# UNITED STATES PATENT AND TRADEMARK OFFICE

10/049,834

Wolfgang Scheibe

<b>Office Action Summary</b>	<b>Application No.</b> 10/049,834	<b>Applicant(s)</b> SCHEIBE ET AL.	
	<b>Examiner</b> Jason J. Boeckmann	<b>Art Unit</b> 3752

**Examiner's Marked Up Figure #3**

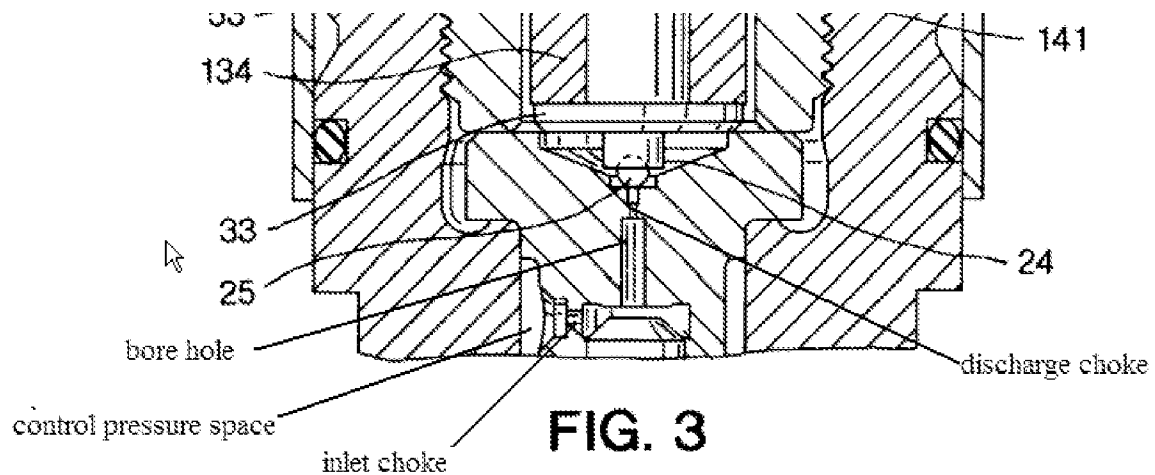
Regarding claims 7, 9, the valve actuator (139) is essentially mushroom-shaped, the stem of the mushroom forming the valve rod and the stop surface of the actuator being an annular collar, concentrically surrounding the valve rod in the region of the mushroom cap (24) (see Fig. 3).

Regarding claims 10, 11, 27 and 28, the valve rod is guided axially movably in at least one guide bushing (134) and is disposed at a small distance from the sealing surface of the actuator (see Fig. 3).

Regarding claims 12, 13, 29 and 30 the length of the valve rod is a multiple of its diameter (see Fig. 3) and the sealing surface is formed in the end face of a disk-shaped insert part (the valve seat) (see Fig. 3) and adjoins the control pressure space on the side averted from the sealing surface.

Regarding claims 14, 15, 17-19, 31, 32 and 34-36 the insert part (also forms a stop for the valve needle ) is formed in two parts with a first part, which contains an opening for the passage fluid and a discharge choke (see examiners marked up figure 3) and a second part at the control pressure space side, with a bore hole (see examiners marked up figure 3) which connects the control pressure space (see examiners marked up figure 3) with an opening for the passage of fluid. The second part contains an inlet choke (see examiners marked up figure 3) near the bore hole (see examiners marked up figure 3). The pressure space is connected with an inlet choke and the rear end of the valve needle (see examiners marked up figure 3) averted from the nozzle needle seat surface lies in the control pressure space.
